INSTRUCTION TO SERVICE

ITS60814		September 15, 2023
SECTION:	549-Heating & Air Conditioning System	
WRITTEN BY:	Aditya Gadepalli	
SUBJECT:	Single Grove to Double Grove AC Belt Rework	
ISSUE:	AC belts on legacy D coaches equipped with ISX engine are failing prematurely.	
SUMMARY:	Rework the coach to have double grove crank shaft and compressor clutch to replace the single grove AC belt with double grove belt.

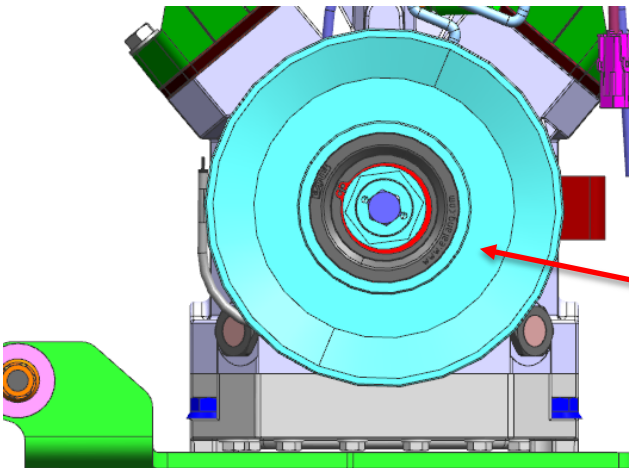
4. Remove and discard the crank shaft pulley. Save the bolts.

Remove and discard the crank pulley. Save hardware.

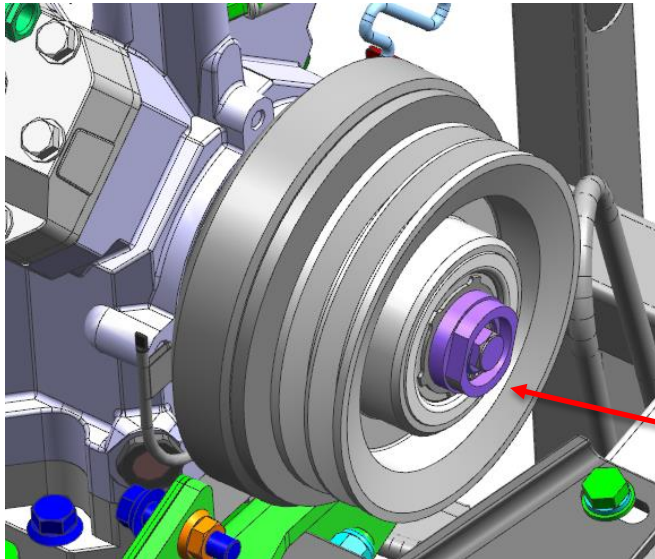
5. Remove and discard the compressor clutch. Save the hardware.

Remove and discard the compressor clutch. Save hardware.

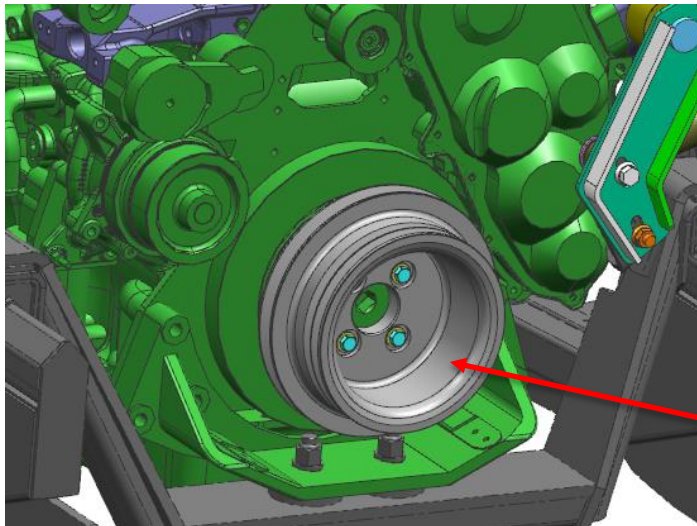
6. Install new clutch, MCI P/N: 08-04-1160, using existing hardware and torque to 63 Ft-Lbs.

Install new compressor clutch, 08-04-1160 using existing hardware.

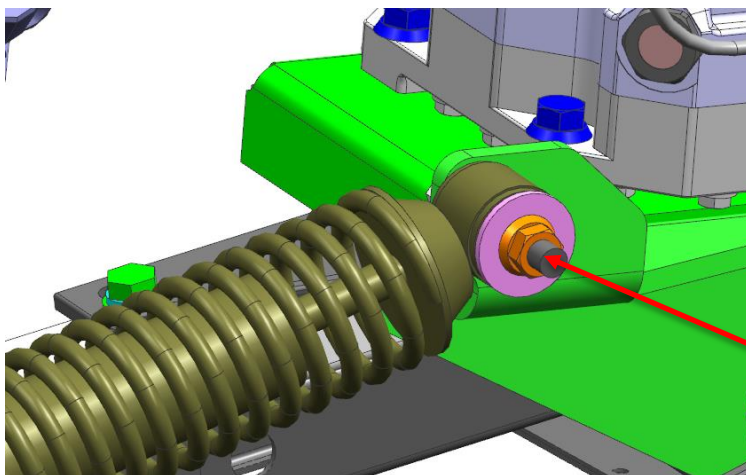
7. Install new crank shaft pulley, MCI P/N: 08-04-1186, using existing hardware. Torque the bolts to 72-78 Ft-Lbs.

Install new crank pulley, 08-04-1186 using existing hardware.

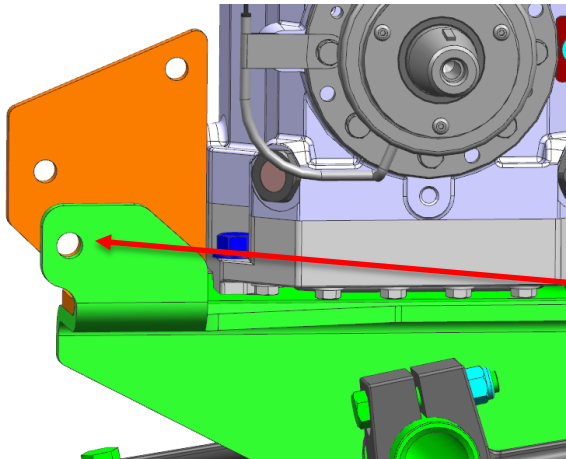
8. Remove and save the hardware securing the spring tensioner to the compressor bed.

Remove and save the hardware securing spring tensioner

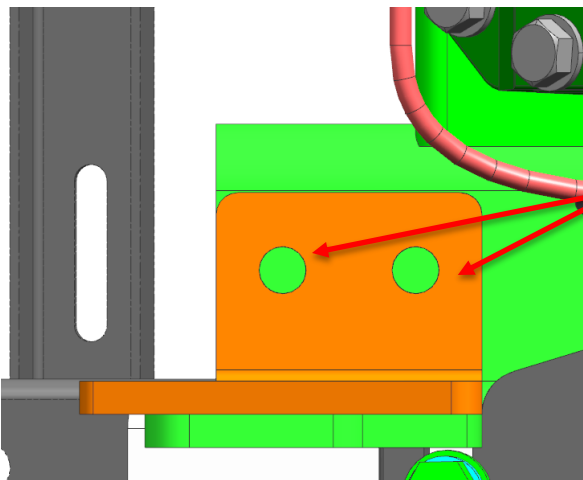
9. Place the new adapter bracket, MCI P/N: 1047272, on the compressor base as shown ensuring the bottom hole in the bracket matches the hole in compressor base.

Place new adapter bracket such that the hole in the compressor base aligns

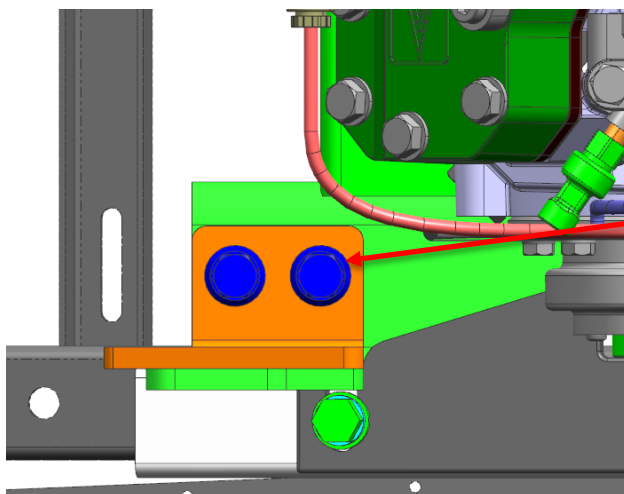
10. Mark the two holes on the bottom flange of the bracket and match drill on the compressor base using 37/32 drill bit.

Match drill two holes using 37/32 drill bit

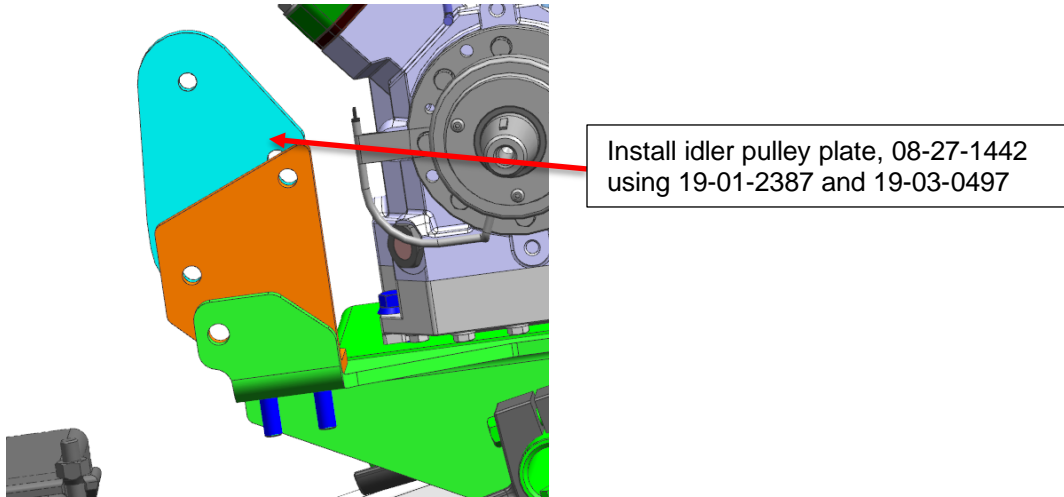
11. Install the adapter bracket, MCI P/N: 1047272, to the compressor base using bolts, MCI P/N: 19-01-2387, and nuts, MCI P/N: 19-03-0497. Torque to 80-90 Ft-Lbs.

Install bracket using 19-01-2387 and 19-03-0497

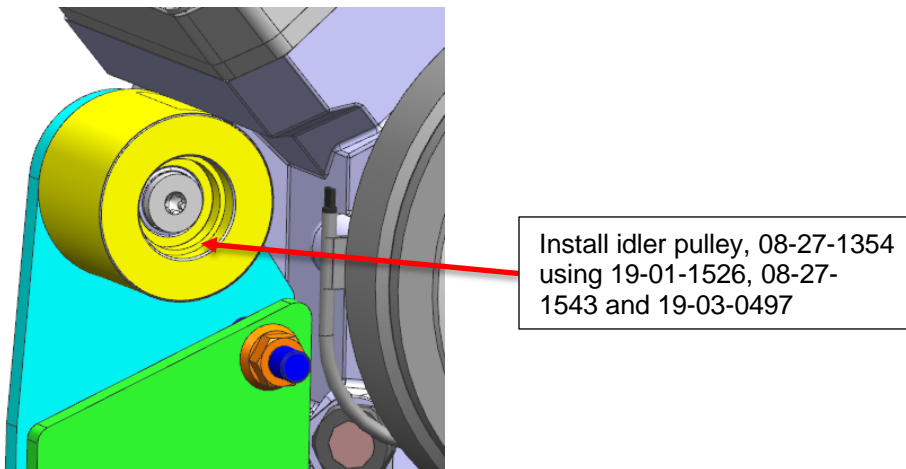
12. Install idler pulley plate, MCI P/N: 08-27-1442, to the adapter bracket using bolts, MCI P/N: 19-01-2387, and nuts, MCI P/N: 19-03-0497. Torque to 80-90 Ft-Lbs.

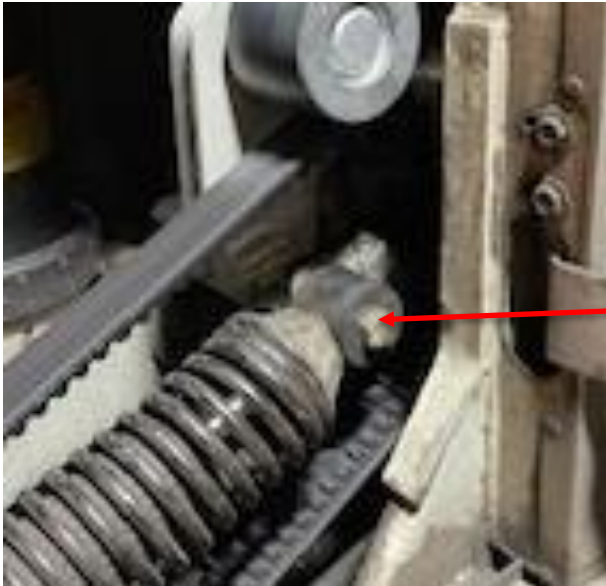
13. Install idler pulley, MCI P/N: 08-27-1354, using bolt, MCI P/N: 19-01-1526, spacer, MCI P/N: 08-27-1543, and nut, MCI P/N: 19-03-0497. Torque the bolt to 25-35 Ft-Lbs.

14. Re-install the spring tensioner to the compressor base, using existing hardware. Torque the nut to 80-90 Ft-Lbs.

Re-install spring tensioner using existing hardware

☞ **NOTE:** Ensure the belt is centered on top and bottom idlers. If not, move the bottom idler in the slots of the bracket and install shims 08-27-1421 between the adapter bracket and idler plate and re-torque the hardware.
